V2500-A1/A5 SERIES PROPULSION SYSTEMS SERVICE BULLETIN

This document transmits the Initial Issue of Service Bulletin EV2500-75-0085

AIR – HP COMPRESSOR STAGE 10 BLEED VALVE – INTRODUCTION OF PARKER HANNIFIN CORPORATION SUPPLIED BLEED VALVE

AIR	10TH STAGE HIGH PRESSURE COMPRESSOR BLEED VALVE	INTRODUCTION OF 5950041-108 AND UPGRADE OF PART NUMBER (P/N) 5950041-105 AND 5950041-107 TO 5950041-108 BY INCORPORATING A NEW SPRING AND PISTON ASSEMBLY.
-----	---	---

Operating Pressures Test Setup
Figure 5

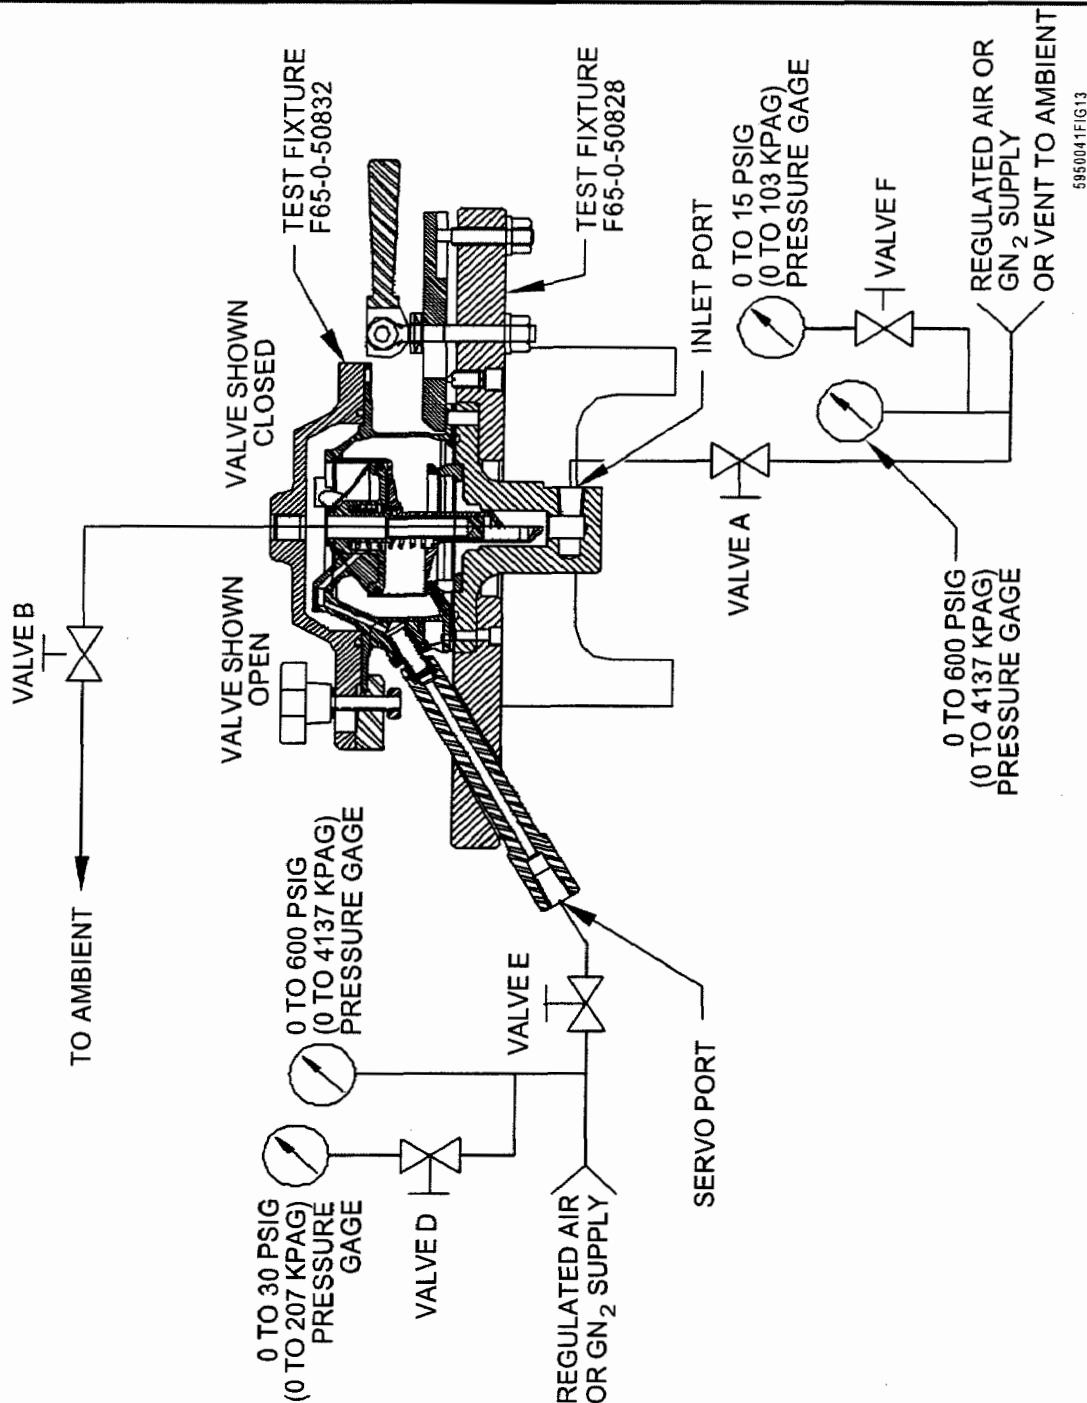
- 1 Reinstall the spring into the test fixture, F65-0-50828. Set up the valve in the test fixture, as shown in Figure 6. Close valves D and F. Open valves A and E.
- 2 With the servo pressure at zero, slowly apply an inlet pressure of 105 to 115 psig (724 to 793 kPag) to close the valve.
- 3 Slowly increase the servo pressure until the valve opens (approximately 110 to 120 psig (758 to 827 kPag)).

- 4 The valve must open at a maximum pressure of 405 psig (2792kPag).
- 5 Reduce the servo pressure to zero to close the valve.

- 6 The valve must close when the servo pressure is reduced to zero.
- 7 Reduce the inlet pressure to zero.
